U.S. Department of the Interior BUREAU OF LAND MANAGEMENT

Notice of Intent

Sundry ID: 2838086

Type of Action: APD Change

[Figure F] 4 String - 2nd Intermediate casing engineered weak point

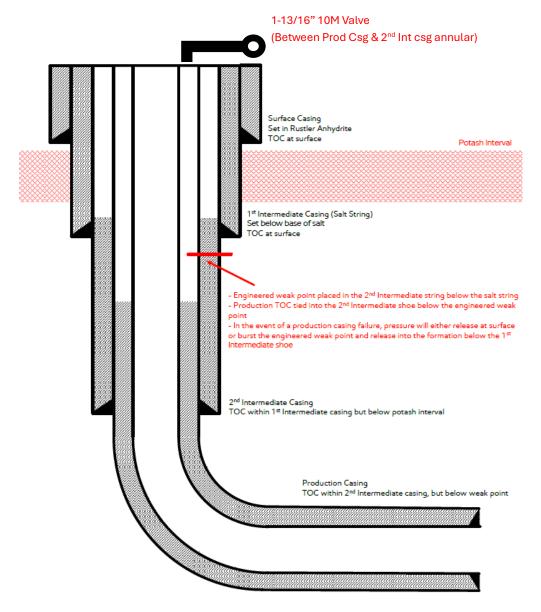
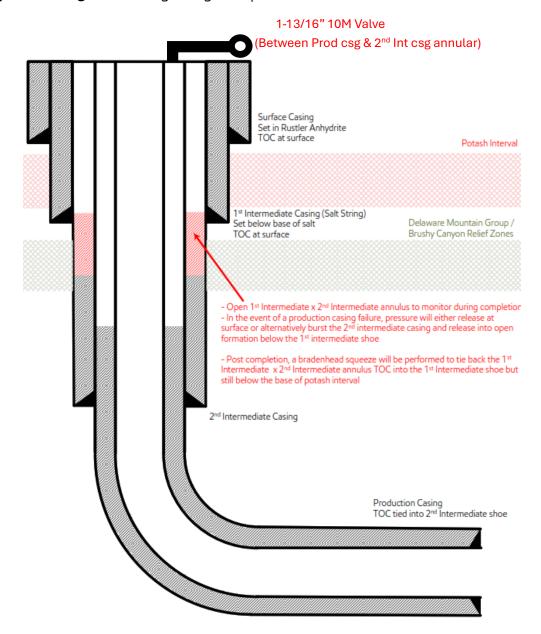
1. Casing design to be changed from the "4-String Design – Engineered Weak Point" (FIGURE F) to the "4-String Design – Open 1st INT x 2nd INT Annulus" (FIGURE D). An open annulus will be utilized and monitored during completions operations.

Post completion, bradenhead squeeze will be performed to tie back the 1st intermediate x 2nd intermediate annulus. TOC will be placed into the 1st intermediate shoe but still below the base of Potash interval.

- 2. No changes to the cementing, casing or mud circulating system designs will be required for the requested change.
- 3. There is no new surface disturbance.

- 1) Alignment with KPLA requirements per schematic above, leaving open annulus open for pressure monitoring during frac and utilizing new casing that meets API standards.
- 2) Contingency plans in place to divert fluids away from salt interval in event of production casing failure.
- 3) Intermediate 2 bradenhead squeeze to be completed within 180 days to tieback TOC to salt string at least 500ft but with top below Marker Bed 126.
- 4) Production cement to be tied back no less than 500ft inside previous casing shoe.
